CONWAY
HISTORIC DISTRICT COMMISSION
STAFF REPORT

5:30 pm • February 24, 2020 • City Hall

Agenda • February 24, 2020

SITE PLAN

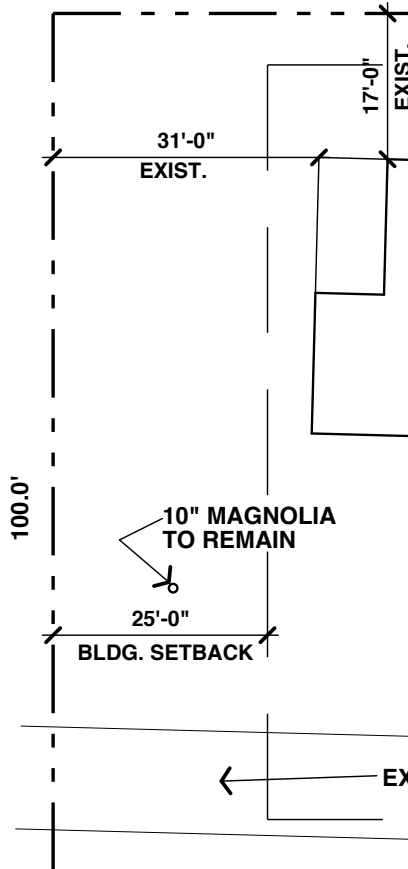
The materials proposed for the carport are appropriate and will match the primary structure. The existing parking pad is placed at the side of the house. The proposed carport will be built on top of this parking pad. This location is quite functional for the

residents of the site, but will result in the structure being very visible from the street. It is recommended the applicant consider a location more toward the rear of the lot. Alternatively, it is recommended that the applicant plant additional landscaping to help obscure view of the structure.

1. The applicant shall plant two deciduous understory trees and additional shrubs north of the new carport to mitigate the visual appearance of the structure from the street.
2. All mechanical equipment shall be placed in a manner to minimize view from the right-of-way or adequately screened.
3. The applicant shall provide a landscaping plan indicating the conditionally required landscaping to the Planning Director prior to issuance of the Certificate of Appropriateness.

Proposed pavilion concept

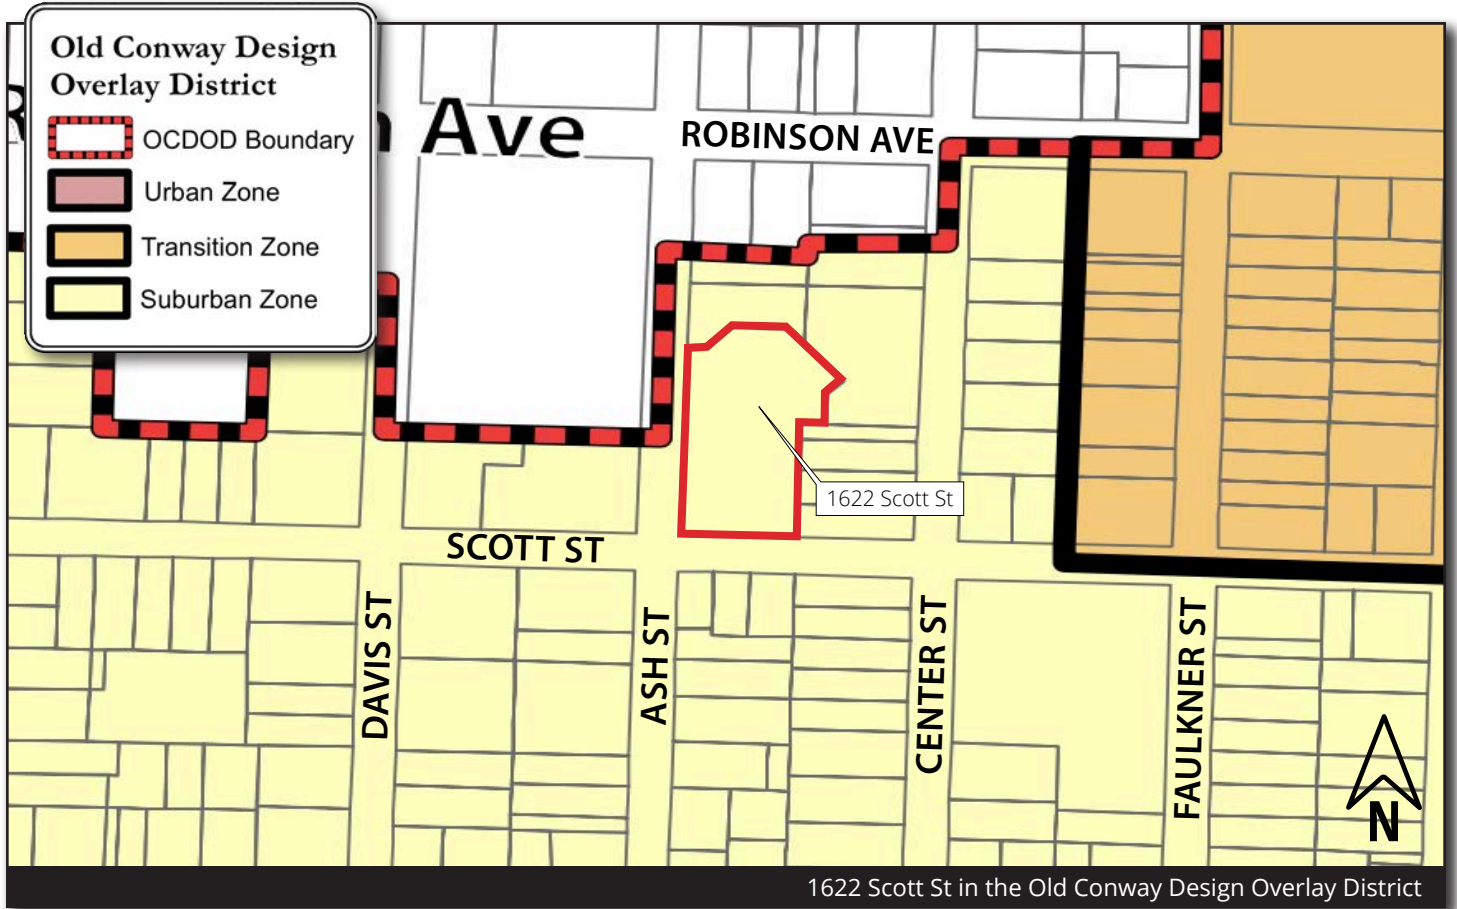
The pavilion, as proposed, is located based on the needs of the facility, though technically in a front yard. The area in which it is proposed functions as a rear yard, but is considered a front yard because of the strange layout of the site. The materials will complement the primary structure.

Staff recommends approval of the fence and pavilion request.

Proposed fencing style

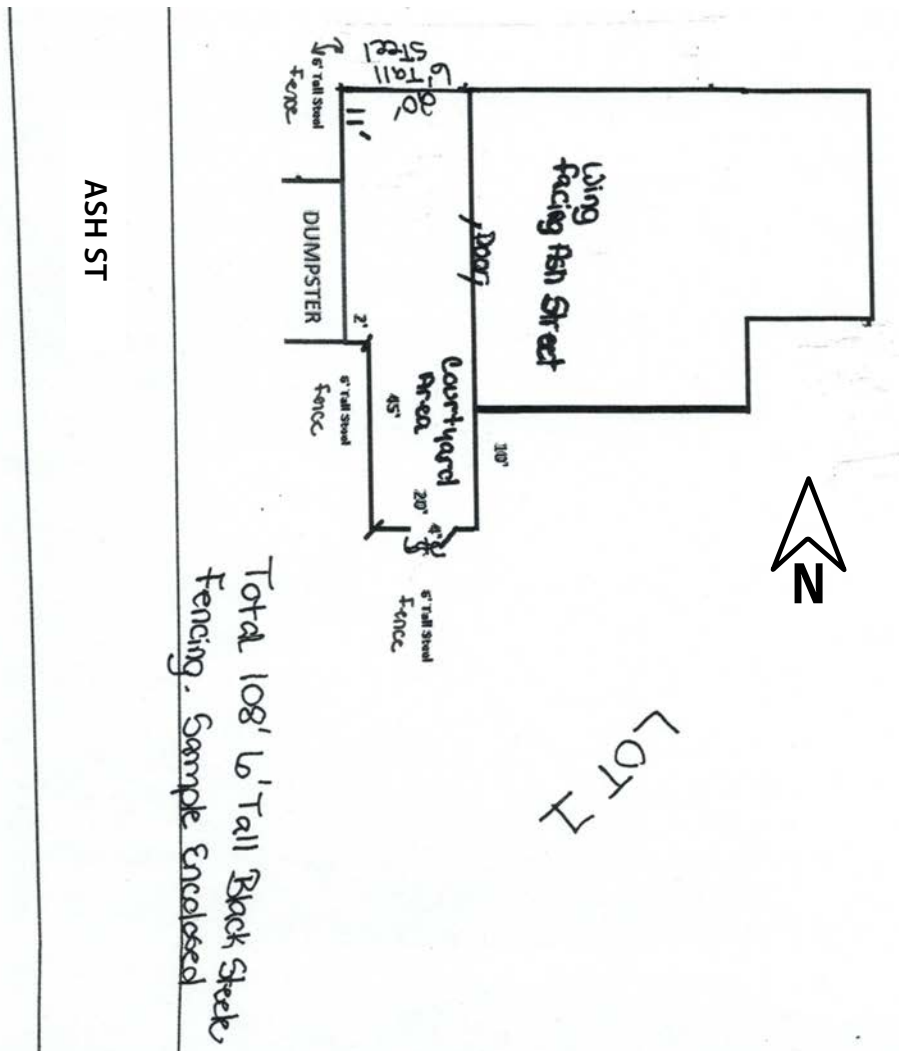
The proposed fencing is located in a front yard that functions as a side yard. The fencing is proposed as black metal and is a result of a state DHS requirement for the facility to prevent climbing by residents in the adjacent memory care wing. The proposed 6' should be considered appropriate in this location.

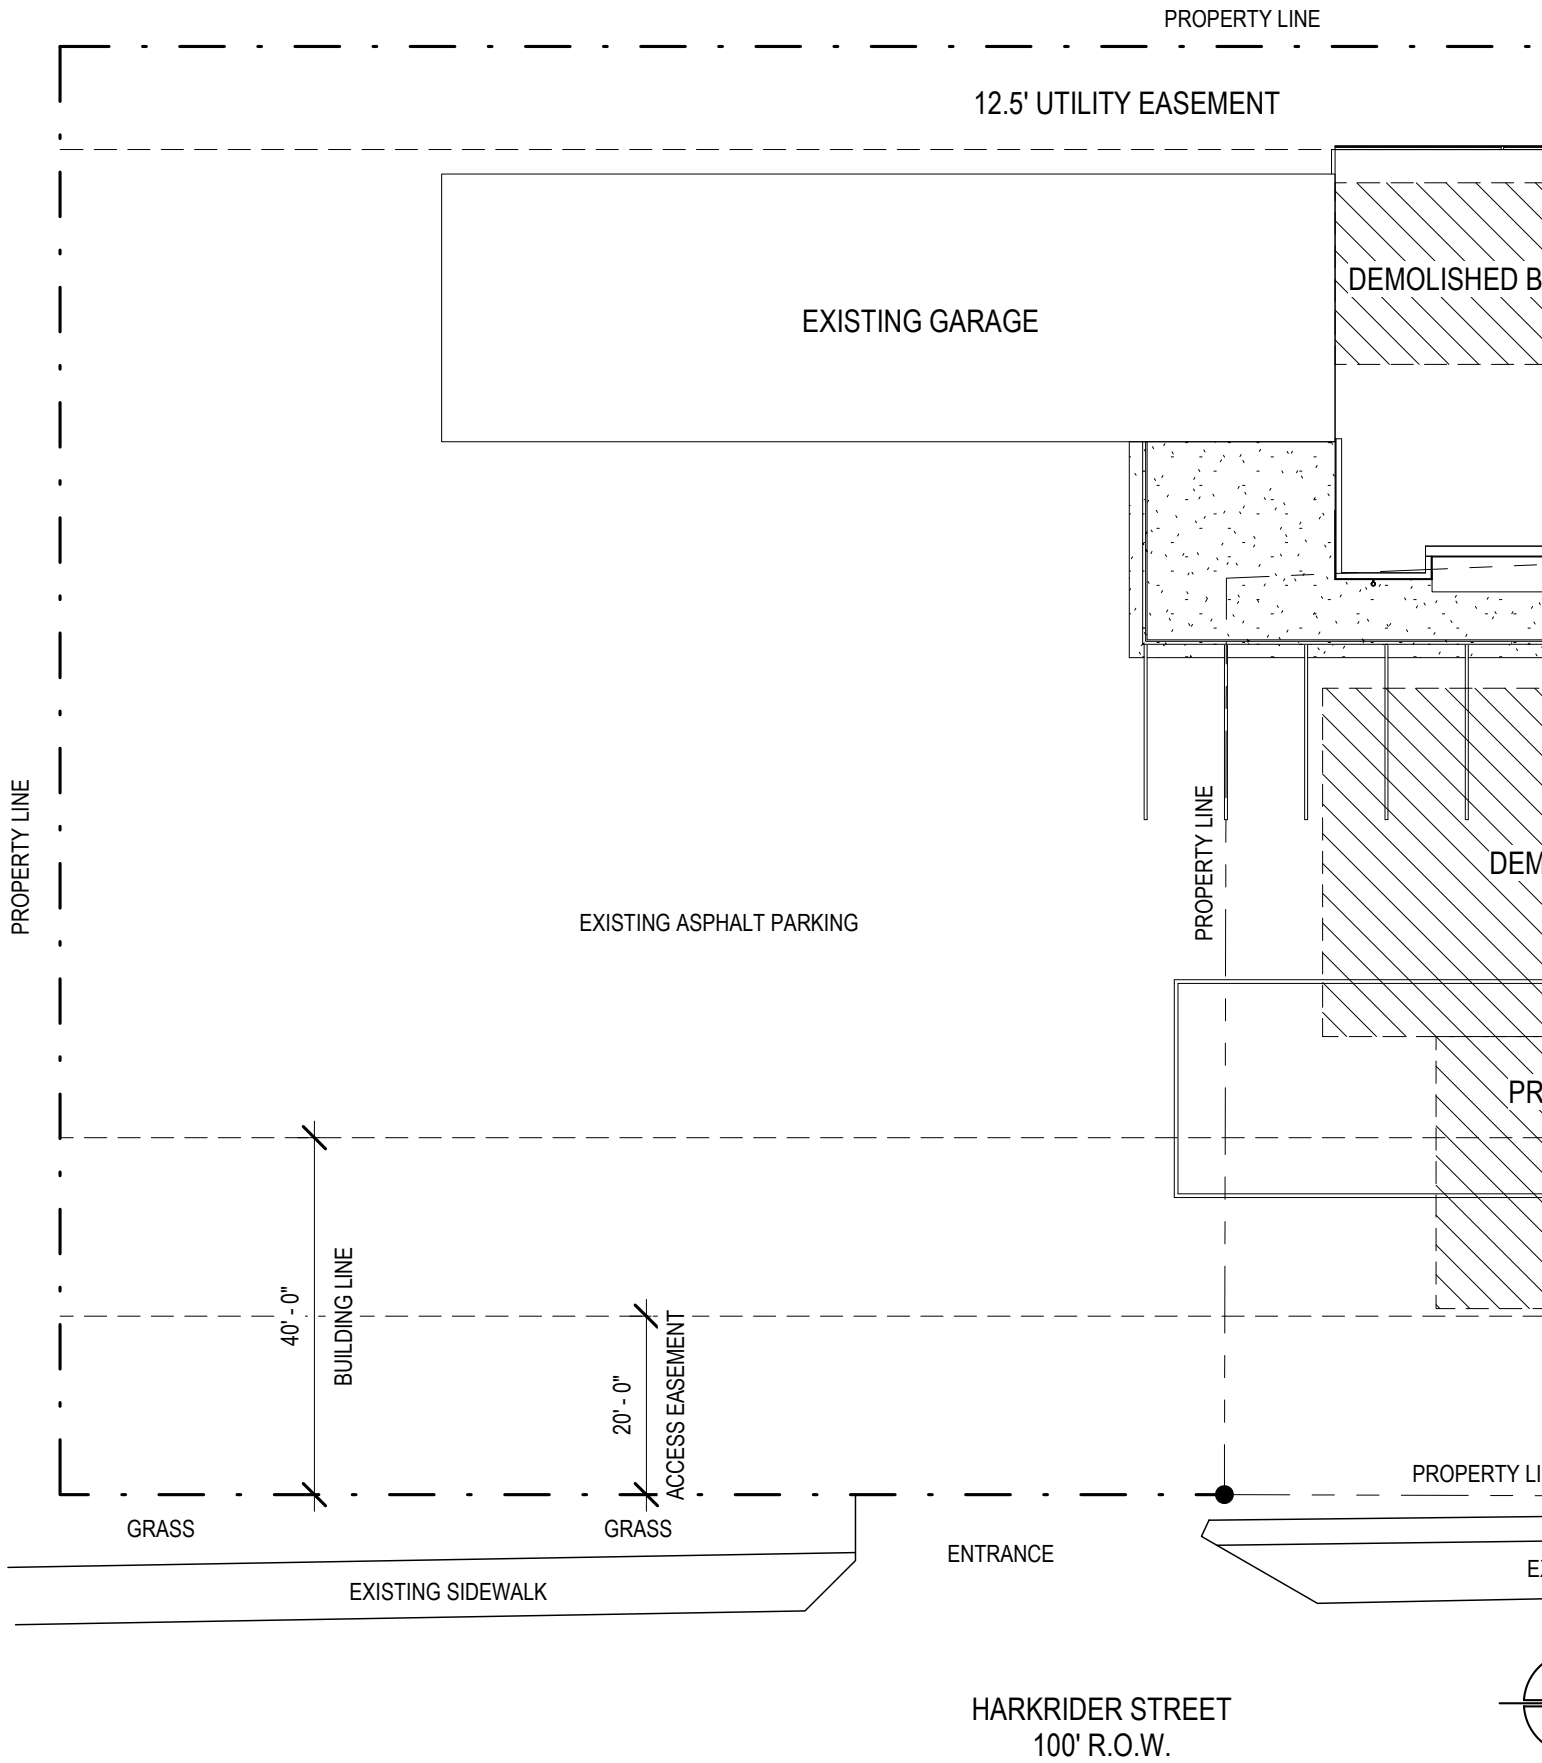
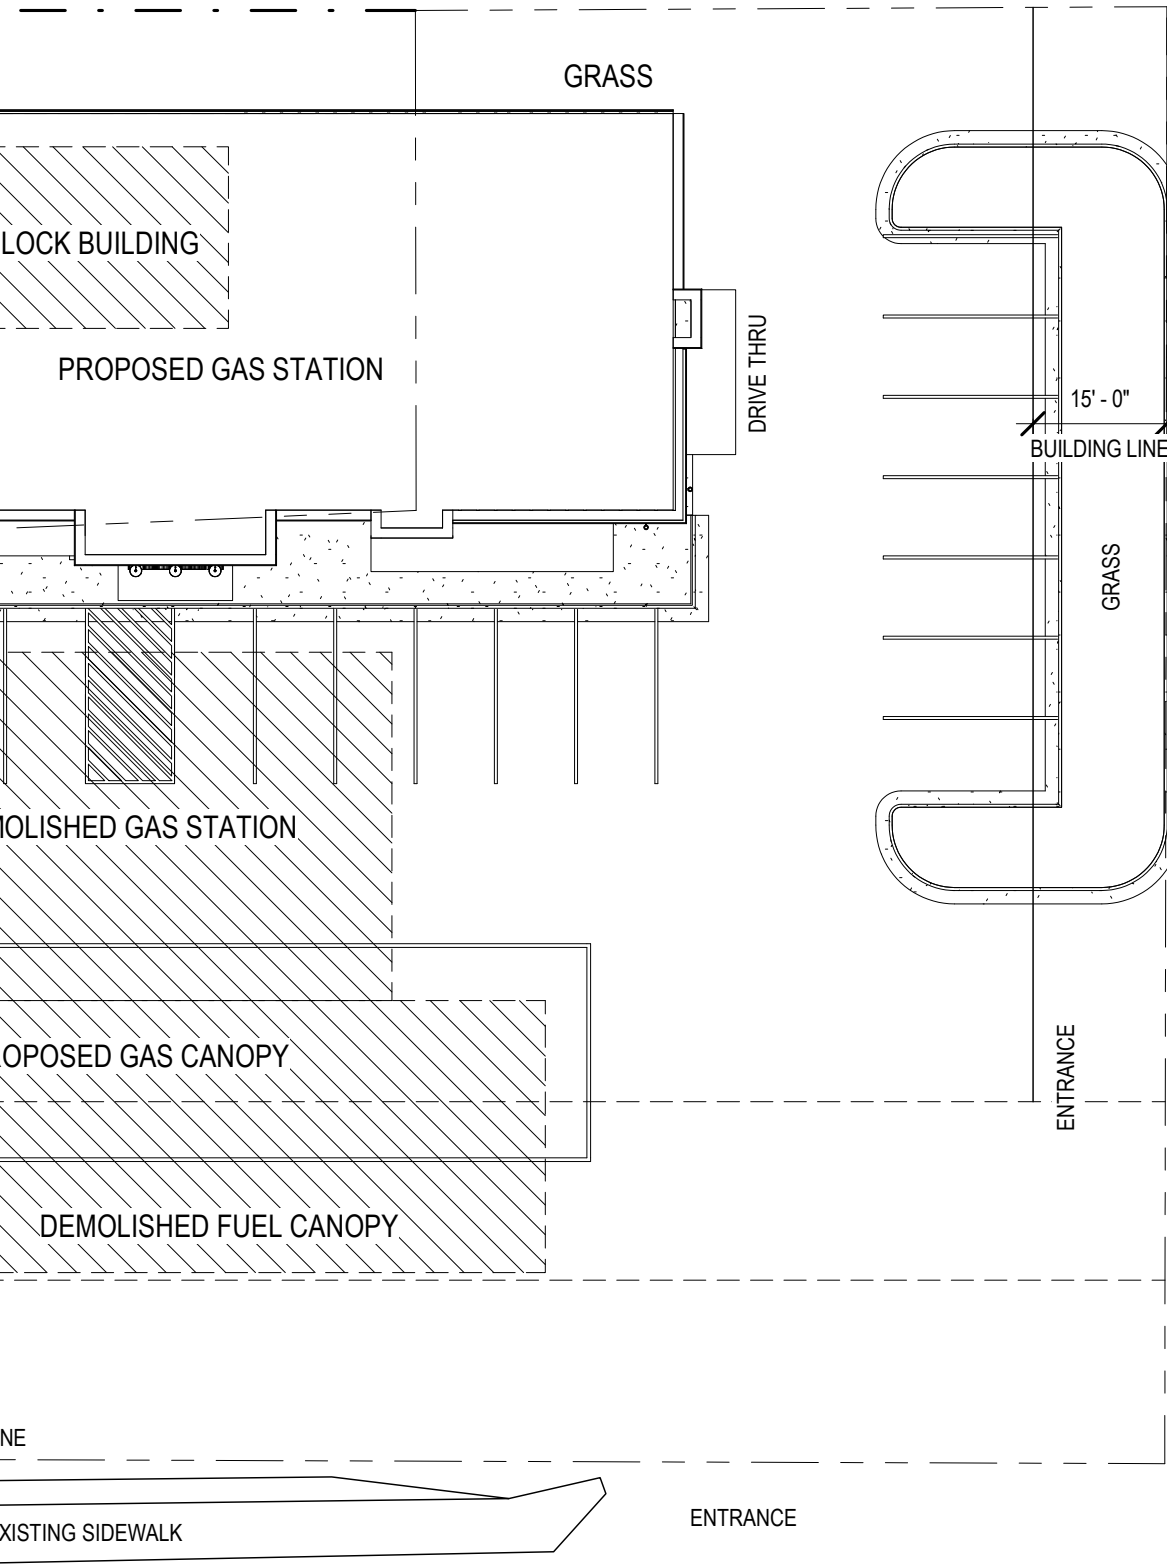
Setbacks and Spacing. Front setbacks are allowed within a range of 85% to 115% of the average front setback of the area. The average setback from the property line for the area is 65', based on the properties to the south along Harkrider St. The included drawings indicate a setback of 102' for the primary structure and an approximately 33' setback for the fueling canopy. The other proposed setbacks conform to the zoning requirements.

The proposed front setbacks are outside of the range of recommended distances, however, given the unique context of the site and the proposed use, the spacing is acceptable.

The applicant is proposing a large surface parking area at a highly visible intersection. Staff has included a condition of approval requiring that a low street wall be constructed along both street frontages.

Vehicular Access Points. The OCDOD encourages minimal curb cuts and thoughtful access. The plan proposes 2 access points on Harkrider St and one access point on Fleming St. The driveways on Fleming St and the northern most driveway on Harkrider St are proposed too close to the intersection and create potential safety hazards.

Staff has included a condition requiring that the northern most driveway on Harkrider St be removed and the driveway on Fleming St be relocated to the west side of the property.

The proposed materials are cultured stone, brick, and metal paneling. The use of metal for exterior cladding is discouraged in the OCDOD and is inappropriate in this location. Staff has recommended a condition that the metal portion of the building be clad in brick as well as the proposed column supports for the fueling canopy. It is also recommended that the upper surround of fuel canopy be clad in architectural materials exclusive of metal.

5. A low street wall shall be constructed along both street frontages to screen the surface parking area.
6. The northern most driveway on Harkrider St shall be removed and the driveway on Fleming St shall be relocated to the west side of the property.

7. The portions of the building proposed to be clad with metal panels shall be clad with brick.
8. The columns or vertical supports for the fueling canopy shall be constructed of brick.

9. The upper surrounds of the fueling canopy be clad in architectural materials that do no include metal.
10. The existing pole sign shall be removed.
11. HVAC equipment be placed in a manner to minimize its visibility from the street.

Architect's rendering of proposed addition

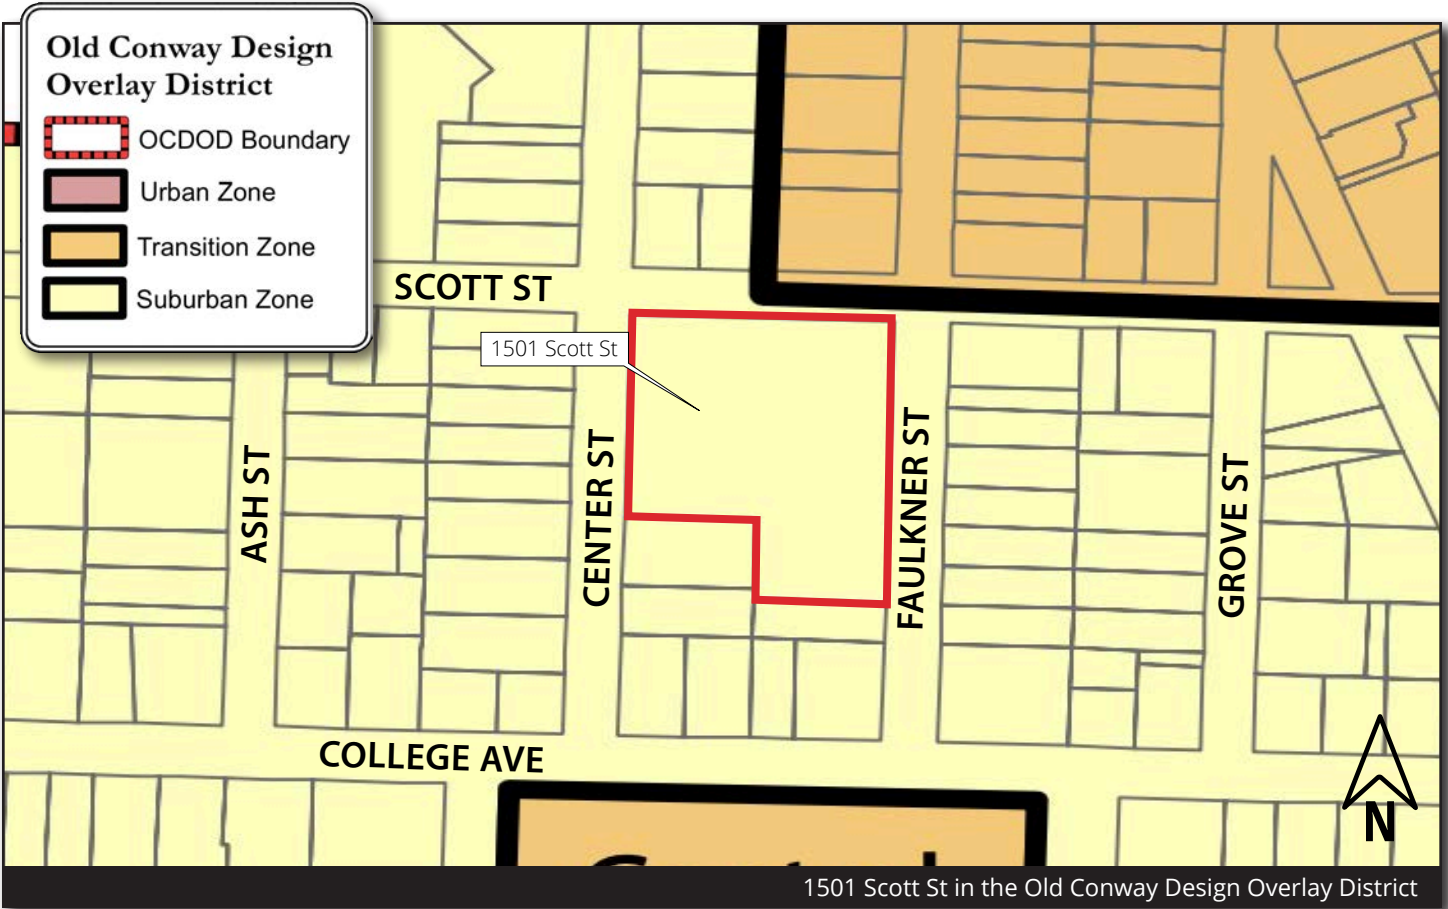
Recommend removing the front portico with the car drop off and moving the addition closer to the street. A portico entrance is appropriate, but should be directed for pedestrian use. Recommend a more monumental entrance that ties the existing structure and addition together.

- *Architecture of the proposed addition should relate to the existing structure on-site in a more direct way (roof forms, windows, materials).*
- *Structure should have more architectural detailing and articulation. The proposed addition has a somewhat box-like appearance. The design regulations call for "monumental" appearance.*
- *Recommend a great deal more windows in the range of 25-40% of each façade wall.*
- *Need details on the specific building materials used. It is assumed EIFS is proposed on portions of the structure. This is not an appropriate material.*

The roof form does not relate to the existing structure on-site and does not appear appropriate.

Staff recommends denial of the project on the following basis:

1. The application does not appear to have made an effort to substantially meet any requirements set forth by the overlay district.
